CONWAY
HISTORIC DISTRICT COMMISSION
MARCH

CONWAY HISTORIC DISTRICT COMMISSION MEETING

1 HENDERSON NEW RESIDENCE - 318 DAVIS STREET

2 DALY'S STEAKHOUSE & LOFTS - 910 & 912 FRONT STREET

Applicant provided elevations and rendered perspectives

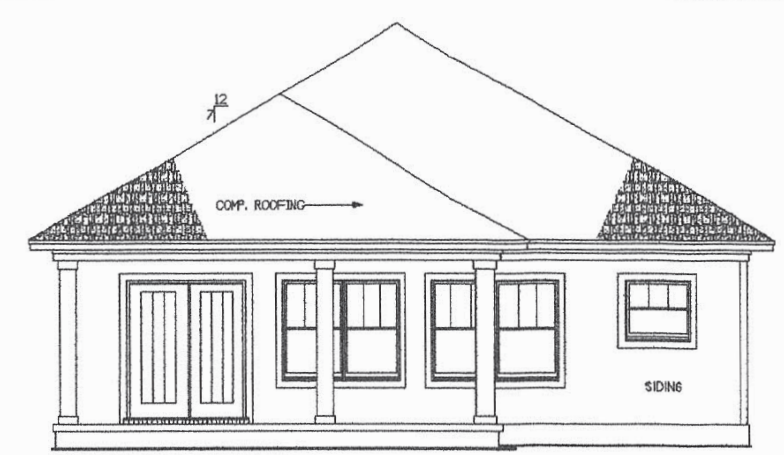
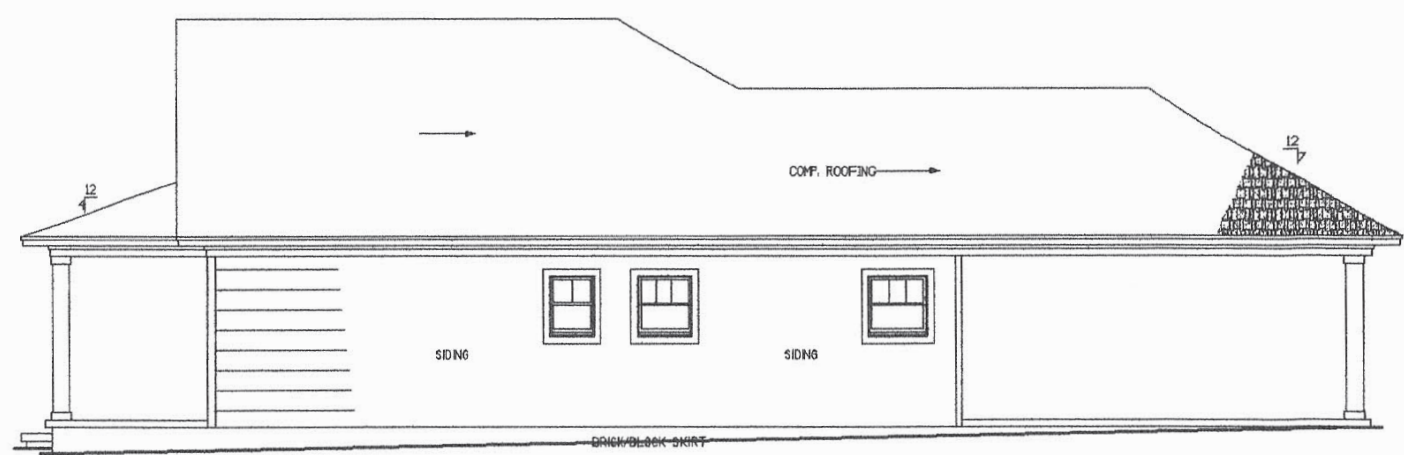
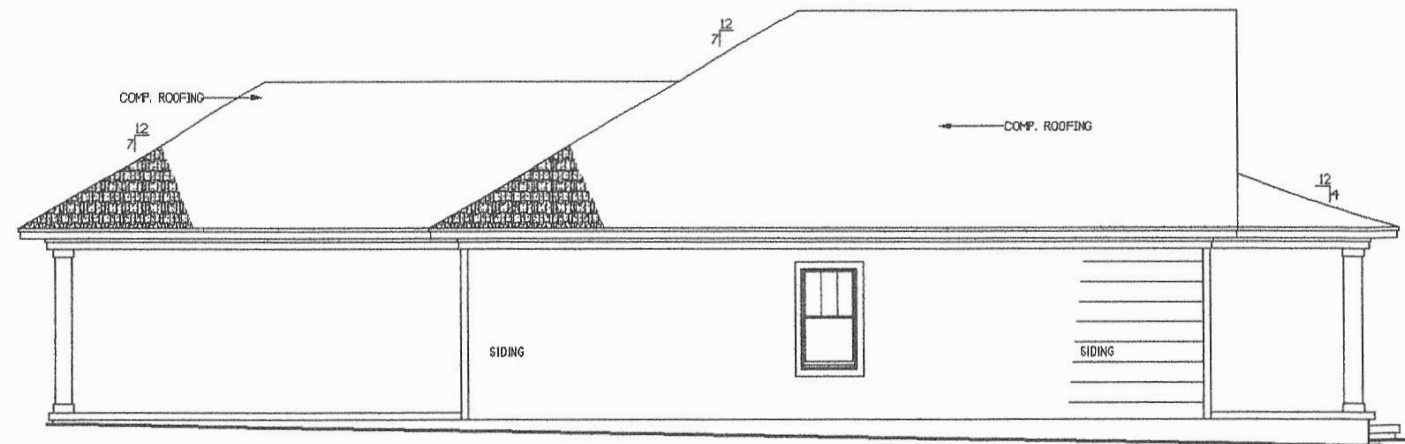
Height. The average height of area structure's eaves and cornices. Also, the first floor elevation / height relationship. The overall height and eave lines are appropriate. The first floor height should be minimally 9 feet floor to ceiling.

Complexity of form. The level of detailing and breaks in wall planes of a structure. The residence has appropriate detailing accomplished with wide window and door trim. The front facade has gabled end with a porch. The complexity of form is appropriate with other area structures.

Entries, Porches, and Porticos. Appropriate entry points are provided. Porches are to be a minimum of 6 feet in depth. The front porch shown is 8 feet in depth and has a metal roof. There is also a rear covered porch. Front porch columns have an appropriate width with a solid appearance.

Doors and windows. The doors and windows shown have muntin dividers creating three over one windows. Simple one over one windows could be more appropriate than windows with false dividers.

Architectural Details, Siding, and Bricks. Eaves, brackets, dentils, cornices, molding, columns, trim, etc. The residence has detailing provided through wide door and window trim and front porch details. These features add traditional detailing. Vinyl siding is the proposed siding material.

1. The residence shall be constructed as shown in submitted plans.
2. The residence's front setback shall be approximately 30 feet from the property line.
3. Front porch columns shall be trimmed out to approximately 8 inches by 8 inches minimum.
4. Floor to ceiling height shall be 9 foot minimum.
5. Vinyl siding shall be allowed.
6. An 8 to 10 foot concrete driveway shall be constructed as shown. A "ribbon" drive may also be used.
7. HVAC and utility equipment shall be appropriately located at the rear or side of the structure and/or appropriately screened.
8. A 4 foot sidewalk shall be constructed along Davis Street or an in-lieu fee of \$480 shall be paid into the sidewalk fund.

ALLEY ELEVATION

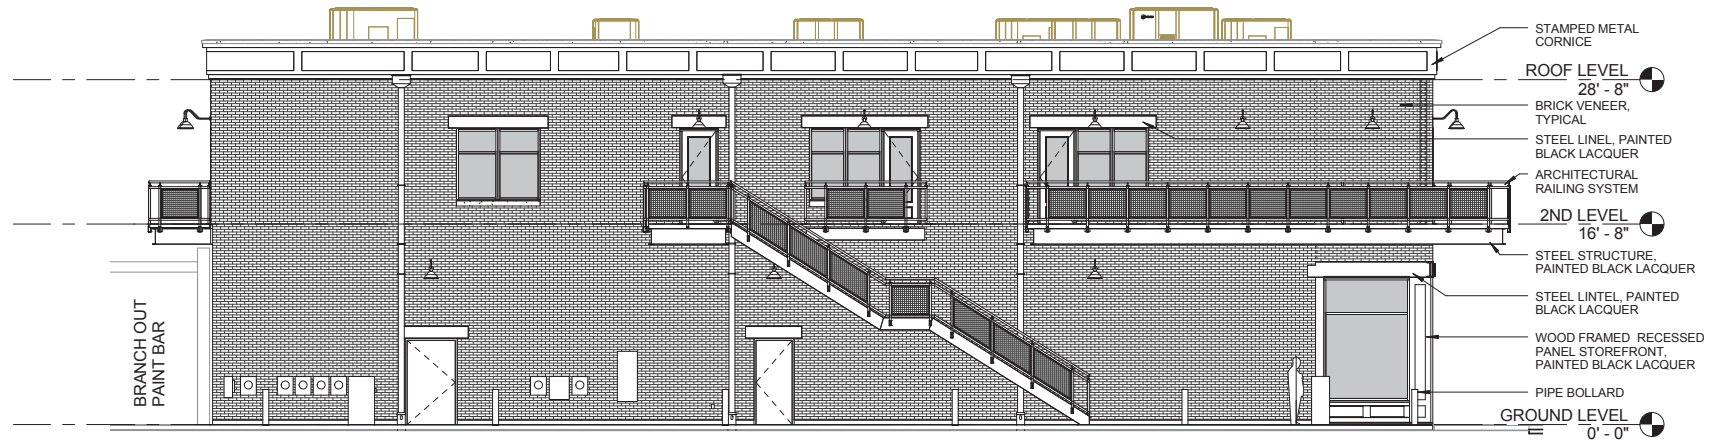
Building materials (other than glass) shall include brick, stone, concrete, architectural metals, stucco/plaster, and wood trim. Historically, these are among the most widely-used, identifiable, and longest-lasting materials within Conway's Urban Zone, and therefore the most desirable for all projects. All materials shall be highly durable, attractive, and easily maintained, especially at street level where pedestrians come in contact with the building. Prohibited materials shall include wood siding, pressed wood siding, composite siding, vinyl siding, and all forms of sheet metal sheathing. Exterior insulated finishing systems (EIFS) are discouraged. (EIFS) shall only be applied in upper story areas or other areas not susceptible to impact damage. These materials are not contextual to Old Conway and are generally perceived to be less permanent in nature, therefore they are not appropriate for use within the Urban Zone. The structure will have a brick front façade. The alley side of the structure is shown with a stucco material. Confirmation of alley side material is needed.

All comments from December are basically unchanged. The new proposal does not change the overall form of the structure. The facade has been changed to reflect a more "simple" modern style. The December proposal showed a new structure that closely resembled the existing Dryer building. The new request adds balconies that serve an upstairs dining room and 4 apartments.

1. Front facade (west), alleyway facade (north), and south wall material shall be brick.
2. Sanitation service area and appropriate screening shall be determined as part of the Planning Department Development Review.
3. City Engineer shall determine proper drainage solution as part of Planning Staff Development Review.
